FSN for 2017-IGTBST-029

URGENT – Field Safety Notice

Bent pedal of footswitch might cause interruption of live Fluoroscopy imaging or exposure.

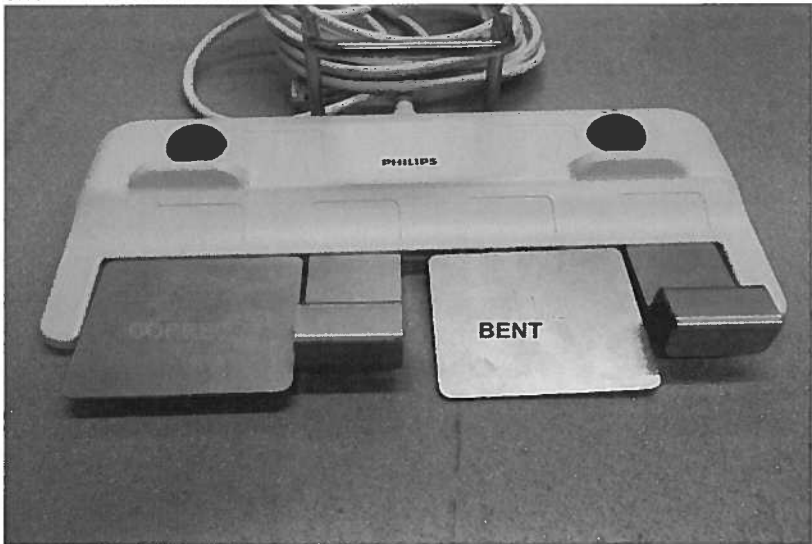
AFFECTED PRODUCTS	<p>System: MultiDiagnost Eleva with Flat Detector Allura Xper FD10 Ceiling Allura Xper FD10 Floor Allura Xper FD10 Allura Xper FD10/10 Allura Xper FD20 Allura Xper FD20 Biplane Allura Xper FD10 Allura Xper FD10/10 Allura Xper FD20 Allura Xper FD20 Biplane Allura Xper FD10 OR Table Allura Xper FD20 OR Table Allura Xper FD20 Biplane OR Table Allura Xper FD20 OR Table Allura Xper FD10 Allura Xper FD10/10 Allura Xper FD20 Allura Xper FD20/10 Allura CV20 Allura Xper FD20 OR Table Allura Xper FD20/20 Allura Xper FD20/20 OR Table Allura Xper FD20/15 Cardio Vascular-Allura Centron</p> <p>Productcode: 708037, 708038 722001, 722003, 722005, 722006, 722008, 722010, 722011, 722012, 722013, 722014, 722015, 722020, 722023, 722026, 722027, 722028, 722029, 722031, 722035, 722038, 722039, 722058 and 722400.</p>
PROBLEM DESCRIPTION	If a Footswitch is frequently used on an anti-fatigue mat, on a non-flat surface or in the pedestal, the footswitch pedals may get bent.

HAZARD INVOLVED	<p>A bent pedal of the footswitch might lead to an intermittent or continuous inability of making live fluoroscopy images or exposures.</p> <p>In case the fluoroscopy pedal is bent and live fluoroscopy is not available, the exposure pedal of the footswitch or the hand switch may be used to generate a live image in order to finish a procedure.</p>
HOW TO IDENTIFY AFFECTED PRODUCTS	Philips will be contacting directly customers with affected systems.

ACTION TO BE TAKEN BY CUSTOMER / USER	<ul style="list-style-type: none"> Before the start of a procedure, the user must check the footswitch for possible bent pedals. See images below on how to identify a bent pedal. If bent pedals are found the procedure should not continue and Local Service should be contacted.  <p><i>Left pedal is correct. Third pedal from left is bent. Distance to floor should be approx. 12mm (0,47inches).</i></p> <ul style="list-style-type: none"> Do not use the footswitch on an anti-fatigue mat or in the pedestal. Please ensure that all staff with access to the affected systems are informed of the content of this Field Safety Notice. Include this Field Safety Notice together with the documentation of the system until the system has been corrected by Philips.
ACTIONS PLANNED BY PHILIPS	<p>The problem will be resolved by an update of the mechanical hardware of the Footswitch that will prevent that the pedals of the footswitch becoming bent.</p> <p>This mechanical hardware is available by February 2019.</p> <p>You will be notified by your local Philips representative to schedule a date for installation of this mechanical hardware update.</p>
